Economic Commission for Europe**Inland Transport Committee****World Forum for Harmonization of Vehicle Regulations****Working Party on Passive Safety****Seventy-fifth session**

UN Regulation No. 153 (Fuel system integrity and electric power train safety at rear-end collision)**Proposal for the 01 series of amendments to UN Regulation No. UN Regulation No. 153 (Fuel system integrity and electric power train safety at rear-end collision)****Submitted by the expert from France ***

Model B

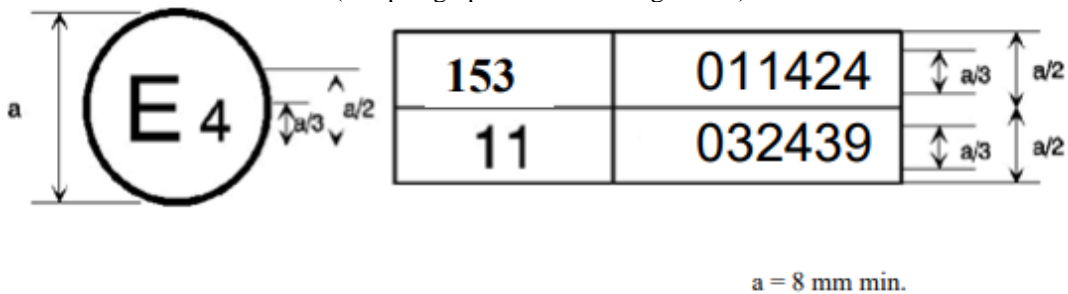
The first two digits of the approval numbers indicate that, at the dates when the respective approvals were granted, UN Regulation No. 153 **incorporated the 01 series of amendments** and UN Regulation No. 11 incorporated the 03 series of amendments"

Figure 3
 Jointed Test Finger

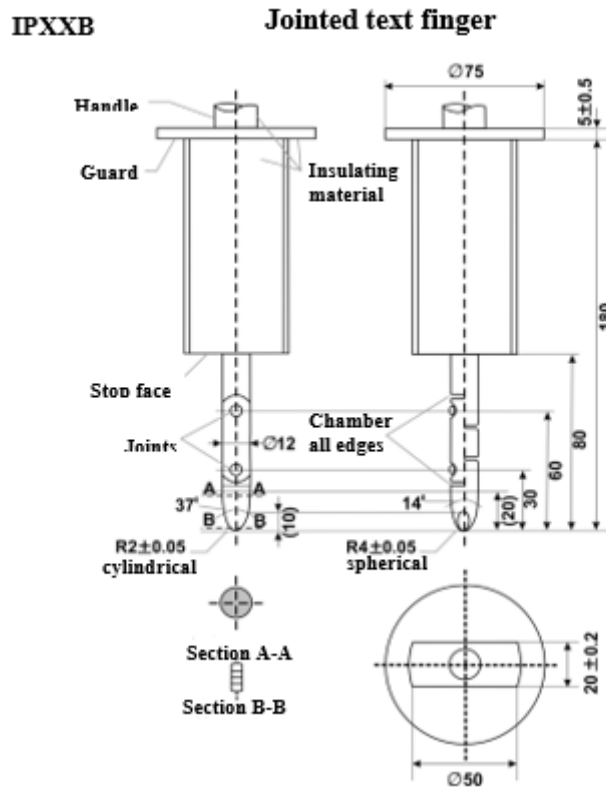
Annex 5, paragraphs 4. and 4.1., amend to read:

The jointed test finger described in Figure 3 shall be inserted into any gaps or openings of the physical protection with a test force of $10 \text{ N} \pm 10$ per cent for electrical safety assessment. If partial or full penetration into the physical protection by the jointed test finger occurs, the jointed test finger shall be placed in every position as specified below.

Starting from the straight position, both joints of the test finger shall be rotated progressively through an angle of up to 90° **degree** with respect to the axis of the adjoining section of the finger and shall be placed in every possible position.

- (a) \ominus on angles: $+0/-10$ seconds $0^{\circ}0'0''/0^{\circ}0'10''$;
- (b) \ominus on linear dimensions:
 - (i) **up to** ≤ 25 mm: $+0/-0.05$ mm;
 - (ii) **over** > 25 mm: ± 0.2 mm.
